**SUSITNA
HYDROELECTRIC PROJECT**

FEDERAL ENERGY REGULATORY COMMISSION
PROJECT No. 7114

**ALASKA POWER AUTHORITY
COMMENTS
ON THE
FEDERAL ENERGY REGULATORY COMMISSION
DRAFT ENVIRONMENTAL IMPACT STATEMENT
OF MAY 1984**

**VOLUME 2B
TECHNICAL COMMENTS
-AQUATIC RESOURCES**

OPTION?

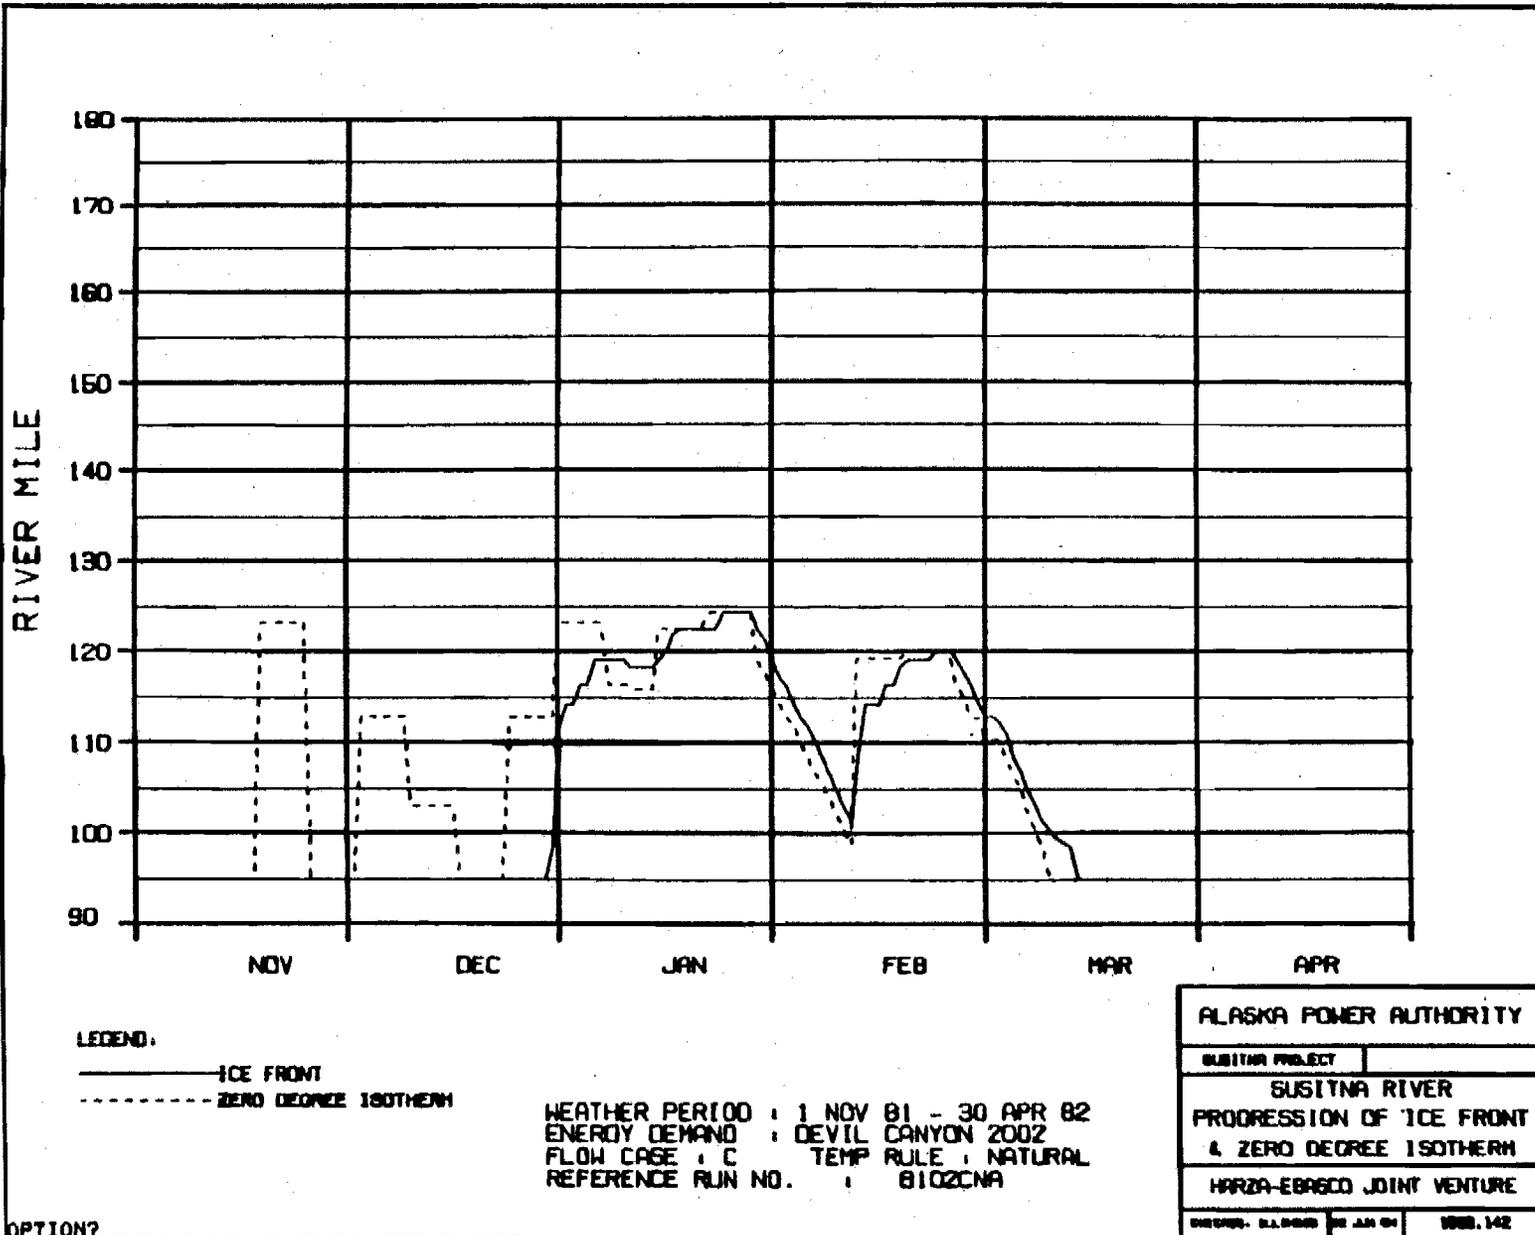
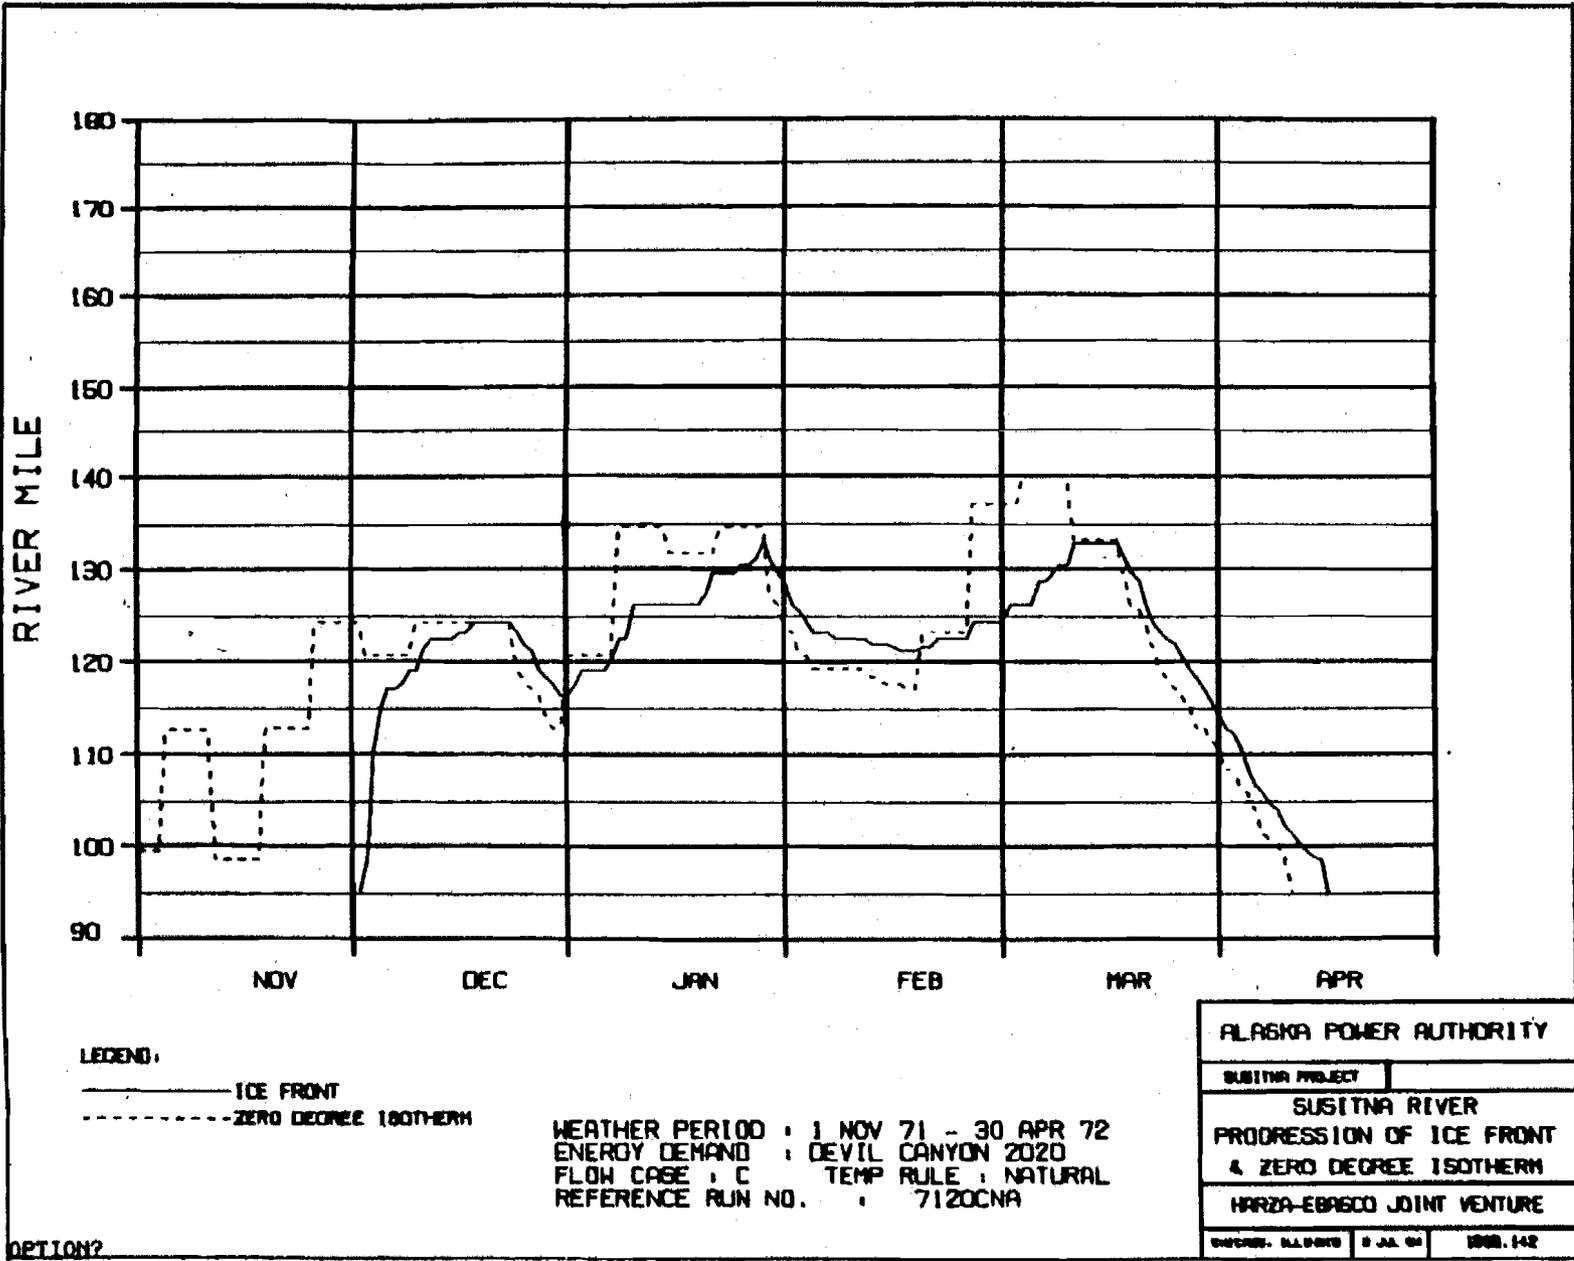
the observed beginning for progression up the middle reach was around November 2 (Exhibit A). With Watana only, the progression is expected to begin on December 10 (Exhibit B).

Higher winter flows with-project are expected to result in generally thinner ice, but slightly higher water levels (with less staging) than preproject. The most significant difference is the zone of open-water downstream of Watana with-project. For instance, simulations using the 1982-83 winter climate data indicate that the open-water zone would extend approximately 60 miles downstream of Watana (Exhibit B). Even with the higher winter power demand in year 2001, and with the addition of Devil Canyon operation in 2002, the ice front is expected to advance only approximately 25 miles upstream of the Chulitna confluence. (Exhibits C, D, and R).

Using the 1976-77 winter hydrological and meteorological data, with average air temperatures similar to 1982-83 for simulated natural conditions the ice front would reach Gold Creek (River Mile 136.6) in late February (Exhibit B). With Watana only operating the ice front would reach Gold Creek in late March (Exhibit E). With Watana and Devil Canyon operating the ice front would advance only approximately 25 miles upstream of the Chulitna confluence (Exhibit F).

In cold winters such as 1981-1982, under natural conditions the ice front would be expected to reach Gold Creek in early January (Exhibit Q). With Watana only operating the ice front would advance to Gold Creek in late January (Exhibit G). With Devil Canyon operating the ice front would only advance to near River Mile 125, downstream of Slough 8A (Exhibit J).

The with-project meltout will generally take place over a longer time period than pre-project breakup. Exhibits A-R show meltout occurring in 2-4 weeks, whereas pre-project breakup generally occurs in 1-2 weeks.

Figure 1: Hypothetical Relationship between Mainstem Discharge and Total Wetted-Surface Area in a Slough

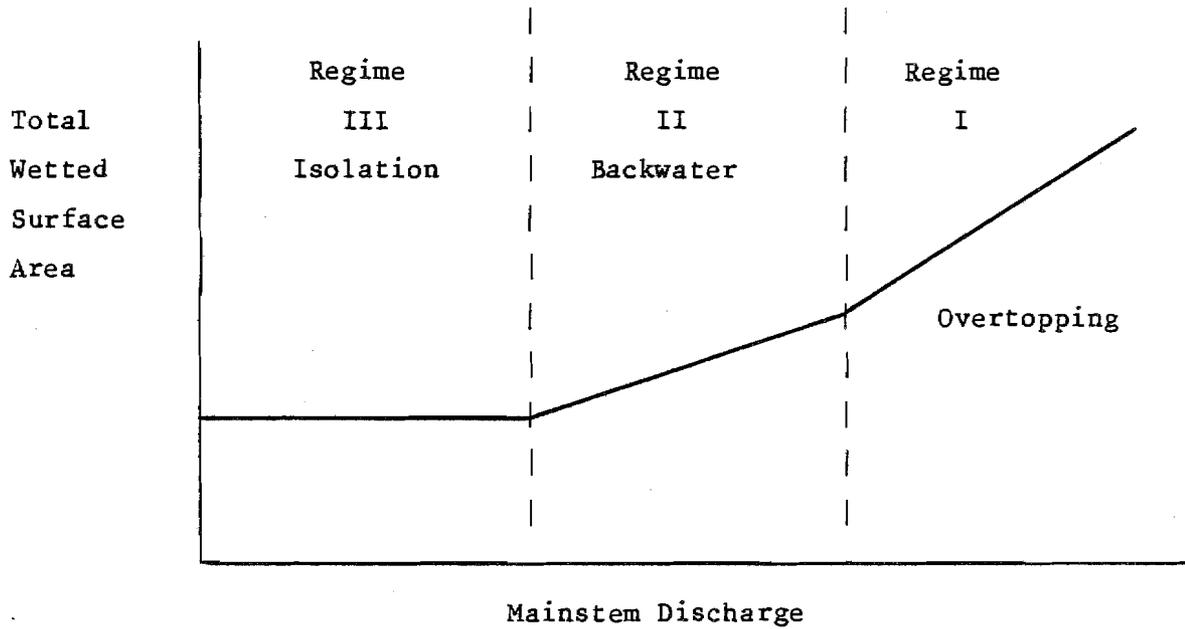
Evaluation of the effects of with-project discharge on total wetted-surface areas in sloughs as presented on page DEIS H-37 is dependent upon using an appropriate data base. To determine the appropriateness of the data base to be used to determine percent change in wetted-surface area, the data should conform to a basic premise describing the relationship between mainstem discharge and the wetted-surface area of the sloughs. The effect of mainstem discharge on wetted-surface areas in sloughs is shown schematically in the attached Figure 1.

The results presented in Table H.3-6 indicate that the wetted-surface area of Slough 21 decreases with mainstem discharge from 20,000 cfs to 12,500 cfs. Based on the relation presented in Figure 1, such a decrease would not be expected. The principal reason for the apparent discrepancy is that the study area encompassed by the wetted areas presented in Table H.3-6 include both a portion of Slough 21 and a portion of the side channel complex downstream from the mouth of the slough (ADF&G 1983a, Appendix Plate E-1 delineates the study boundaries for the surface area measurements). Because of the inclusion of some side channel area, conclusions reached pertaining to loss of wetted-surface areas in sloughs are not completely substantiated.

Figure 2. CHUM SALMON NOMOGRAPH

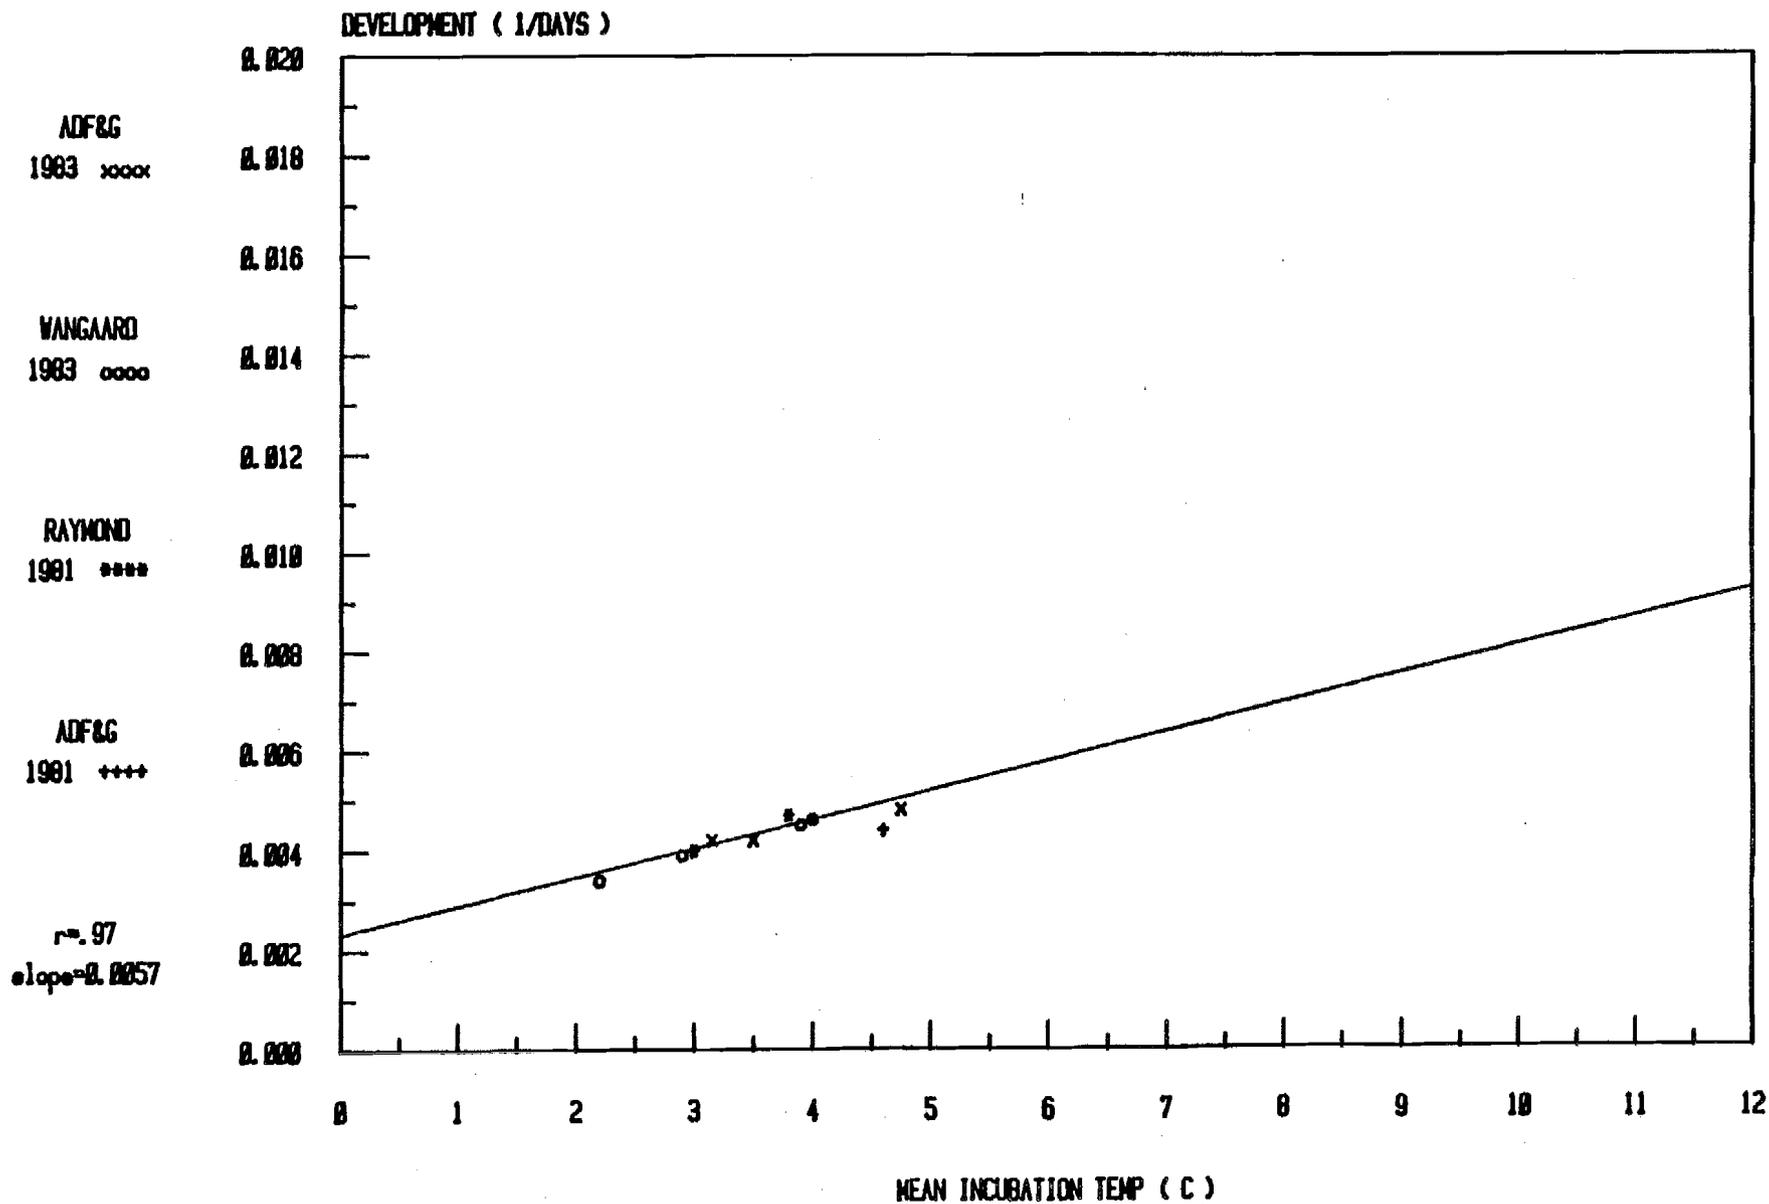
The calculated regression can give an approximate estimate of incubation time. A simplified way of estimating emergence time is to make a nomograph from the development time graph (Figure 2 attached). If the spawning date and average incubation temperature are known, the approximate emergence date can be calculated. For example, chum salmon spawned on September 1 at an average incubation temperature of 3°C would emerge between May 1 and 10. Mean incubation temperatures for the four primary spawning Susitna sloughs ranged from 2.0 to 4.3°C (ADF& G 1983f). Predicted natural mainstem mean temperatures during the incubation period under average climatological conditions was around 1.2°C (Figure 3 attached). Referring to the nomograph (Figure 2) using a spawning date of September 1 at 1.2°C would show fish emerging much later than June 10. This would be too late to assure a viable population and indicates that temperature is a limiting factor in the mainstem under natural conditions. Predicted mainstem temperatures under

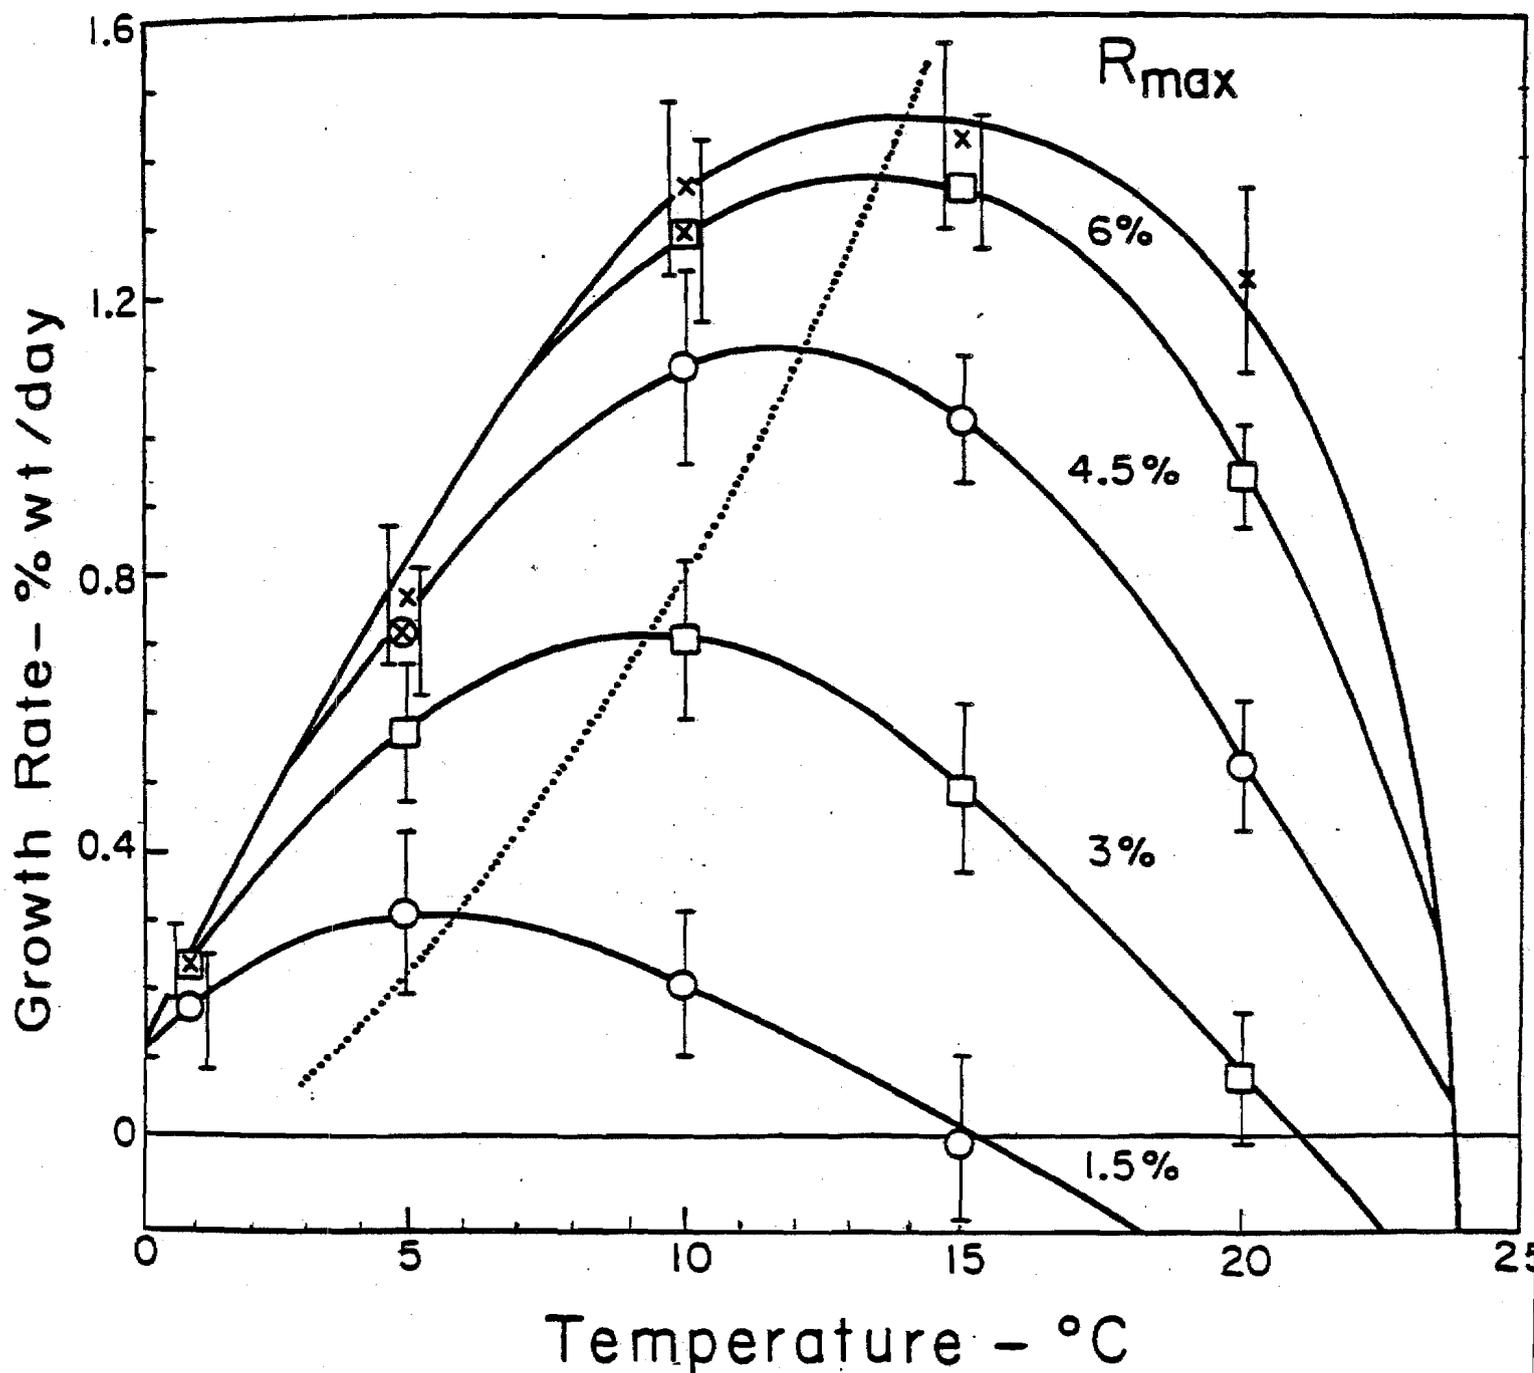
The effect of temperature on growth is a function of ration level (Figure 2, attached). For juvenile sockeye, the optimum temperature for growth decreased progressively from about 15°C at maximum rations to about 5°C at a ration size just above the maintenance ration (Brett, et al., 1969). A similar relation was found for brown trout with a decrease from about 13°C at rations close to the maintenance level (Elliott 1975). Changes in temperature result in relatively smaller changes in growth at reduced rations compared to maximum rations because of differences in the shape of ration versus growth relation. Consequently small drops in temperature during midsummer from 10°-11°C to 8°-9°C (Table 1, July and August) will result in relatively small changes in growth for fish feeding at reduced ration levels (Fig. 1). Since fish in the Susitna River are feeding on a low ration level, the expected changes in growth due to temperature reductions would likely be smaller than predicted in Tables 2, 3, and 4.
